E4419A-10

# Information Only Service Note

## E4419A EPM Series Dual-Channel Power Meter

New Replacement for Power Supply

Figure 1

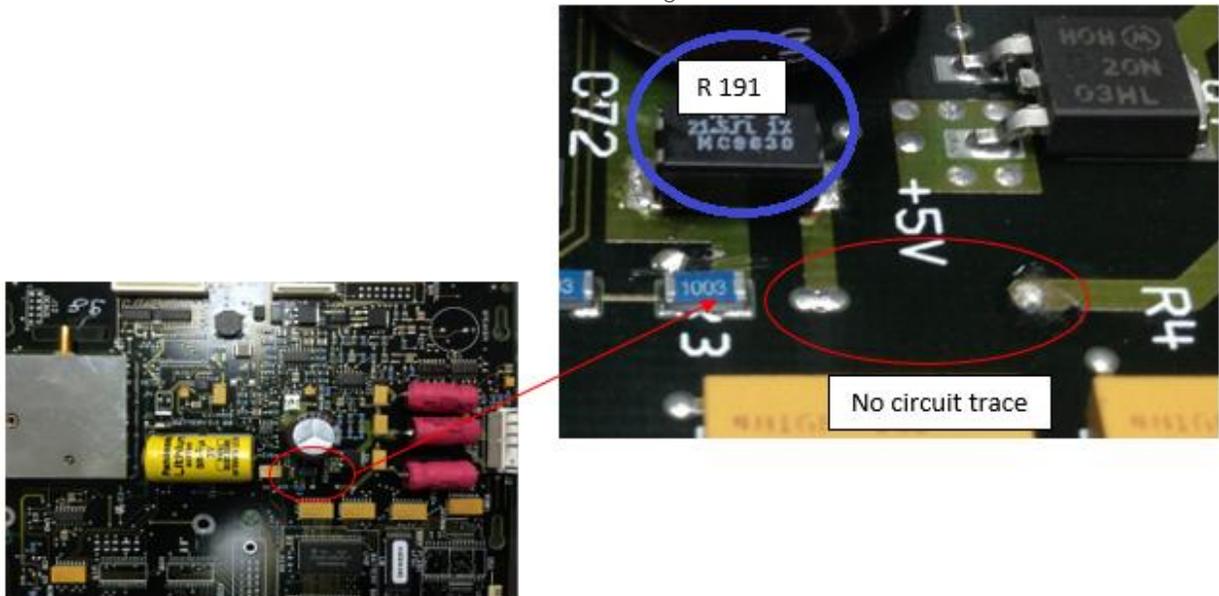
- 1) Check the power meter are using E4418-60001 Processor Assembly
- 2) No circuit trace between main +12V PSU to Fan, refer figure 1

- 3) Remove resistor R191 from the circuit board, refer above figure 1
- 4) Mount the resistor perpendicular to the board, and solder the resistor pin lead to the solder pad.
- 5) Using 8150-0452 wire trim the insulator for both end. Solder one end to the resistor pin lead and the other end of wire to circuit trace, refer below figure 2
